# High-Voltage Supply Requirements Review

September 16, 2003

University of Wisconsin-Madison / SSEC

#### Action Item # PDR-4: Coax negative margin

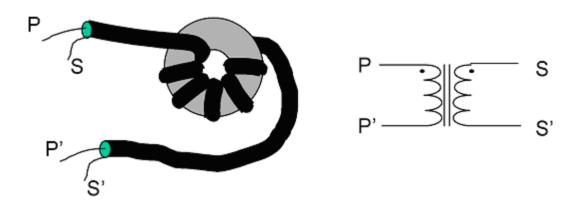
The RG178 coaxial cable used for the PMT signal output transformer operates beyond the manufacturers voltage rating.

It is possible to construct a transformer using a bifilar winding using silicone-insulated wire.

#### **HV Control Board**

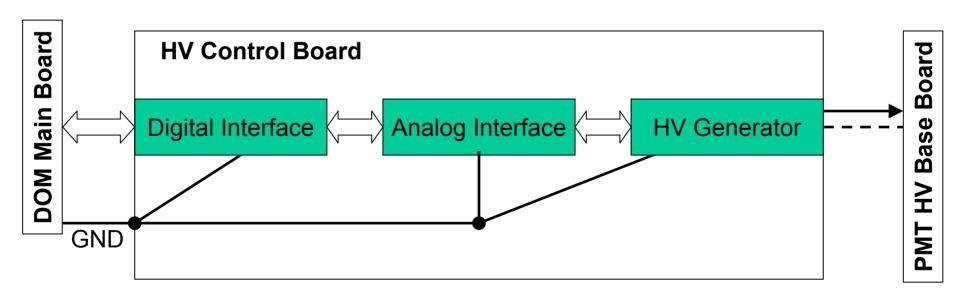
- •Implements the same interface as the Iseg board
- Same ADC, DAC as the Iseg board
- Carries the HV generator
- •No HV traces on control board

## **HV Control Board**

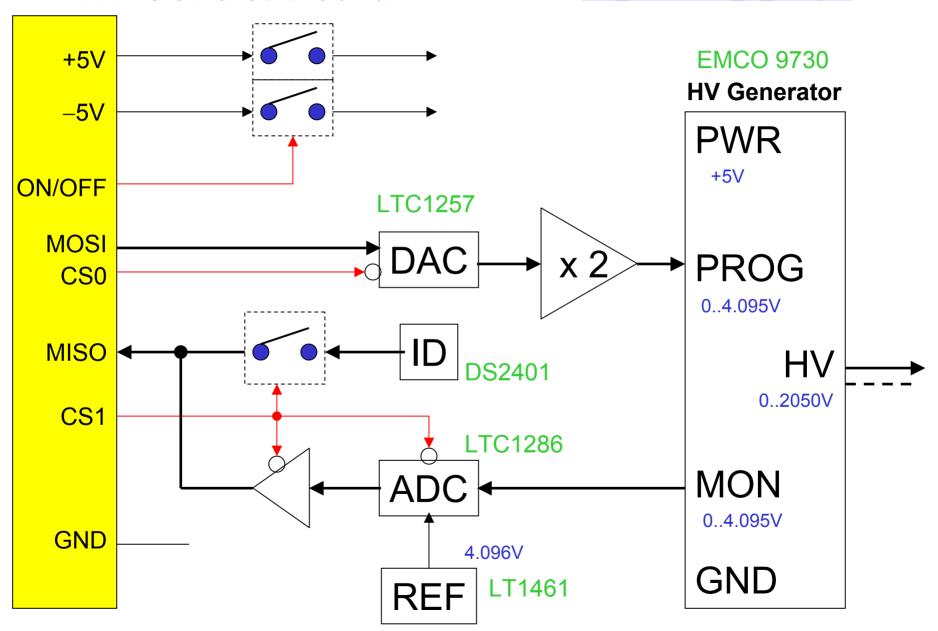
Schematic: HV MODULE B sch.pdf
